Job Title: Outfall Repairs

Job Location: Dewey Beach, DE

RE: PH 1 – Relining
Change Order Request CO #1 – Cleaning at Reed Street

**Re: Town of Dewey Beach
Proposal to Provide CCTV Services and Recommended
Engineering Improvements to Address Stormwater
Drainage Issues on Houston Street**

3 PIPES TO BAY

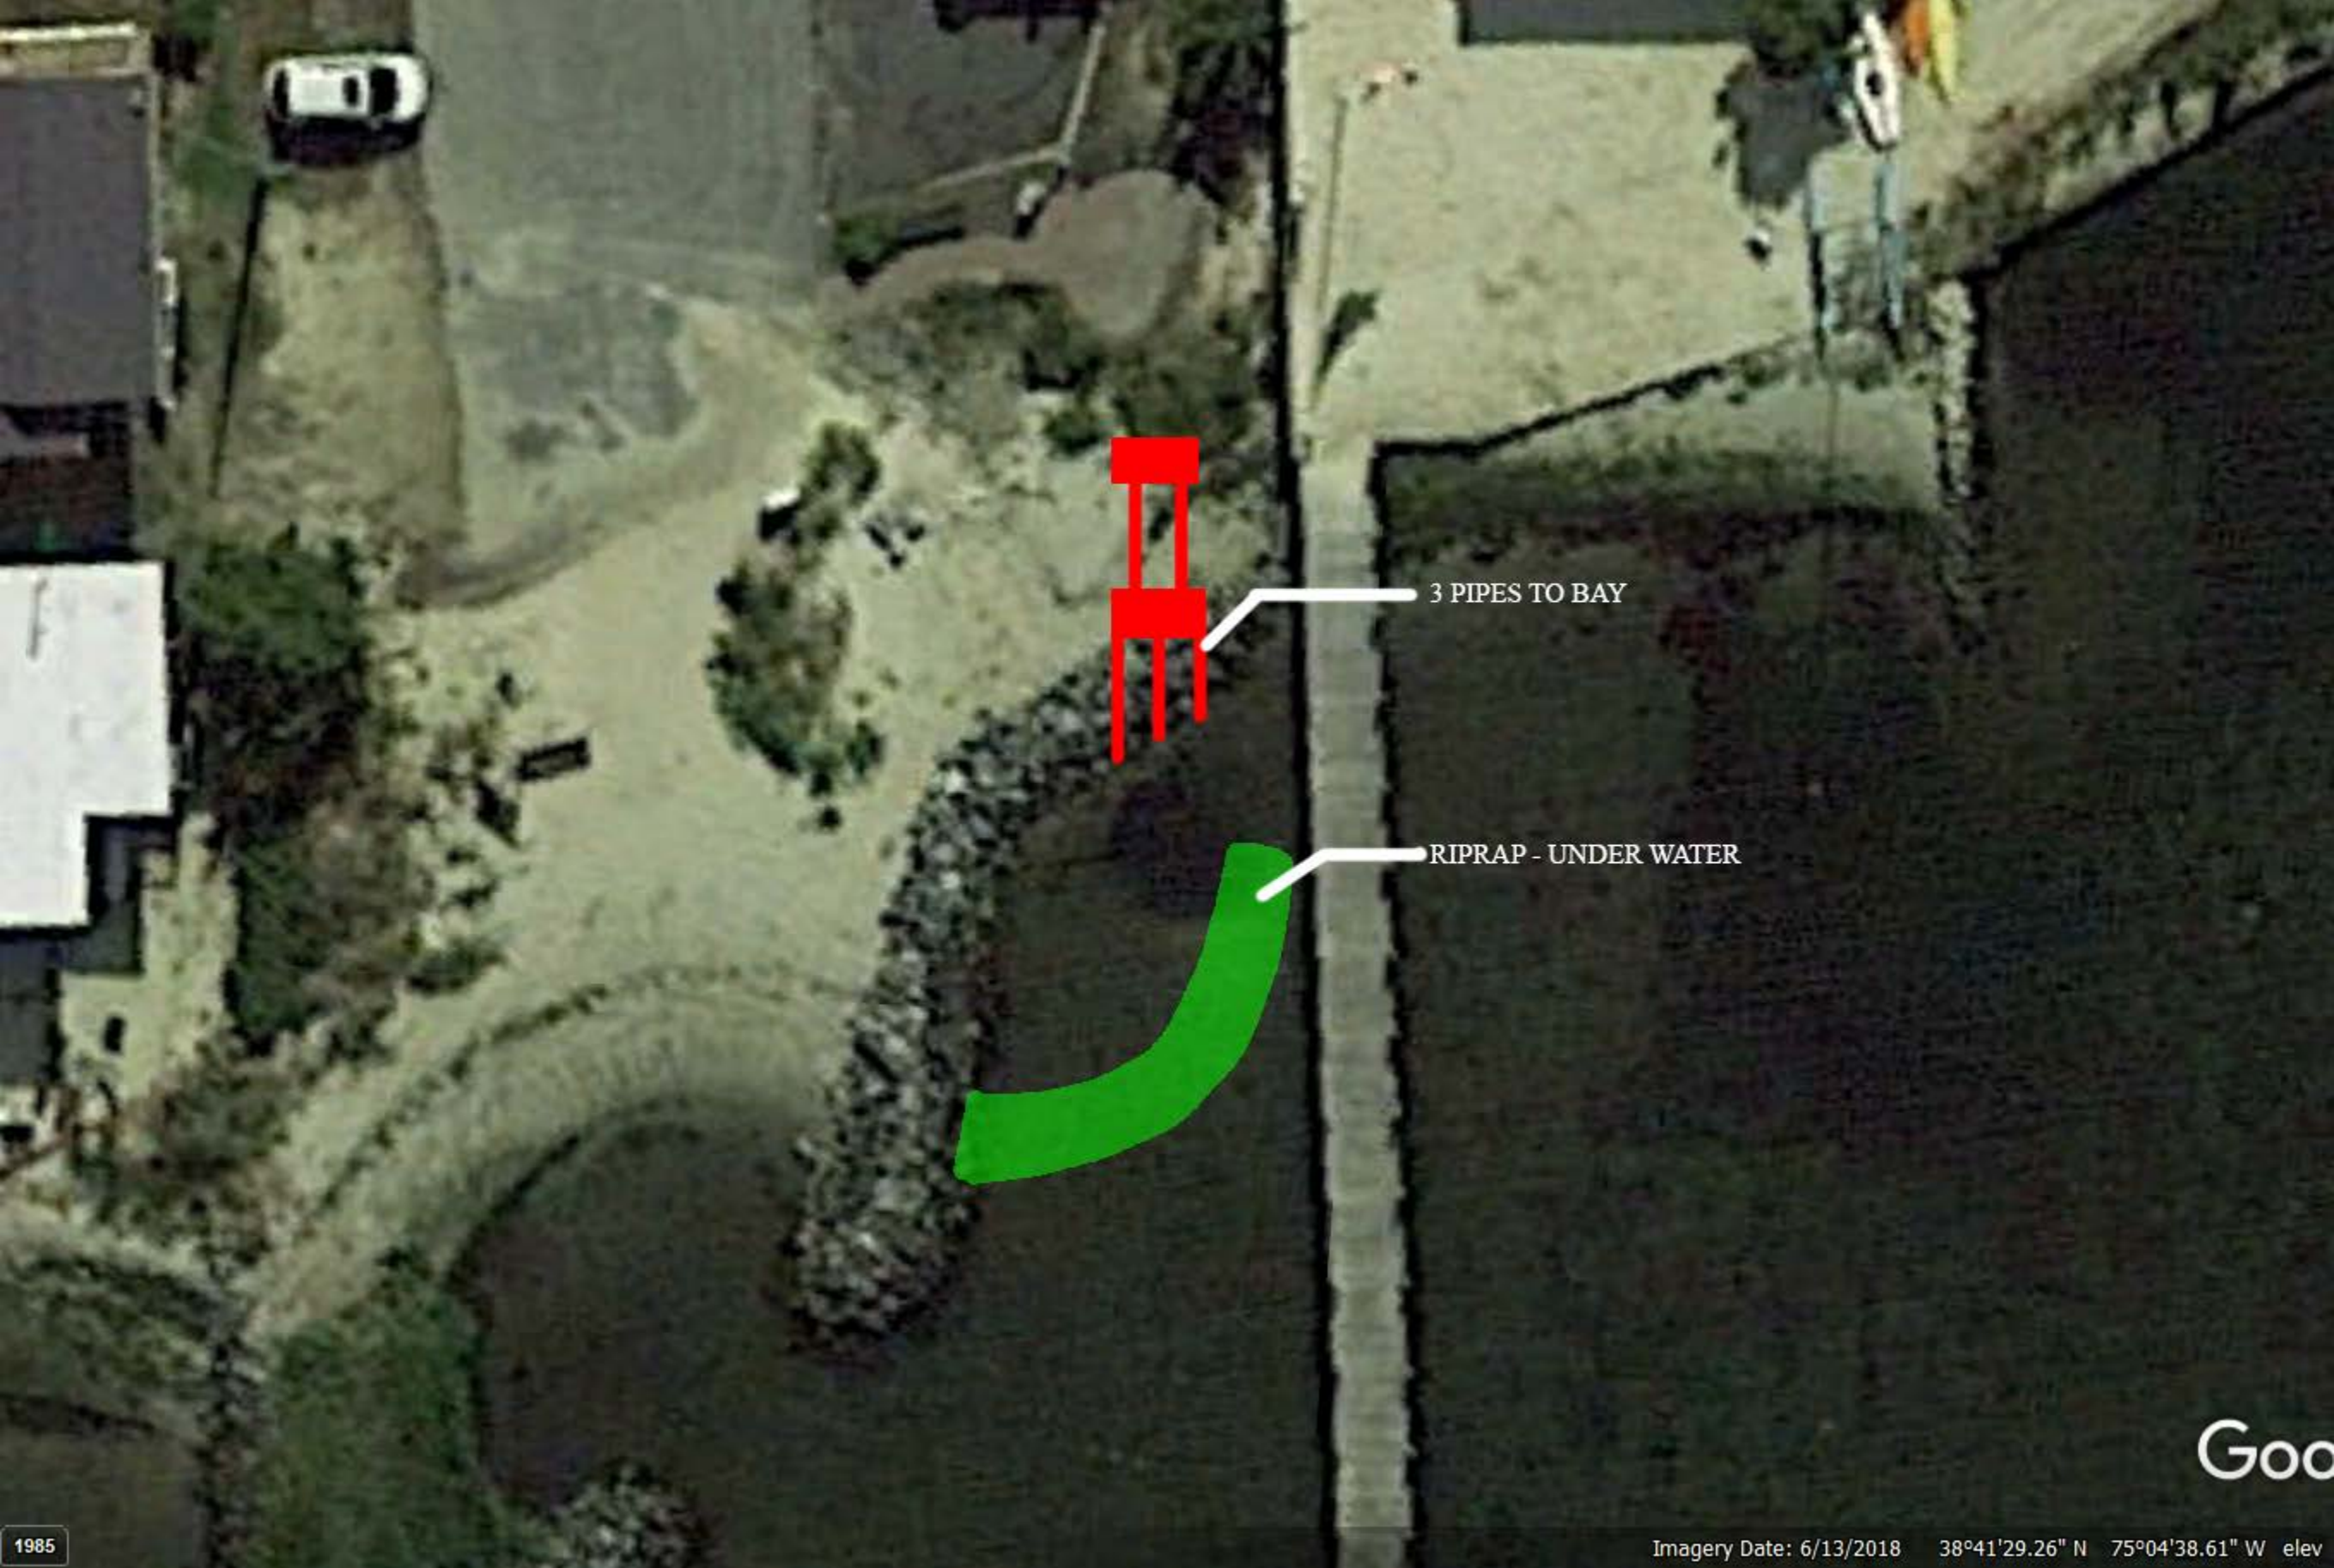
Thanks for talking with me today regarding the specialty cleaning on-site. After some investigation we firmly believe that the valves entering the bay are no longer working properly. This causes sand and water to wash into the pipes during high-tide. It's believed that a large storm may have come in and buried the pipes partially under sand causing backups and flooding. We always expected some silt and debris on these line segments since our last mobilization, but the problems above have caused for far more cleaning than anticipated.

To best repair the three outfalls we would recommend installing a coffer dam around the 3 pipe locations and excavate the sand slightly below the invert of the pipes. While this is being performed, we will clean and televise the outfall pipes. After all silt has been removed, we will stabilize the area by installing an underwater barrier using riprap R-5 or R-6 around the three pipes to protect the area from erosion.

We formally request to be paid 3 days for heavy cleaning the line segments above due to the flooding from the pipes @\$3,400 per day, or \$10,200

Total cost to perform the outfall cleaning.....@\$26,400 Lump Sum
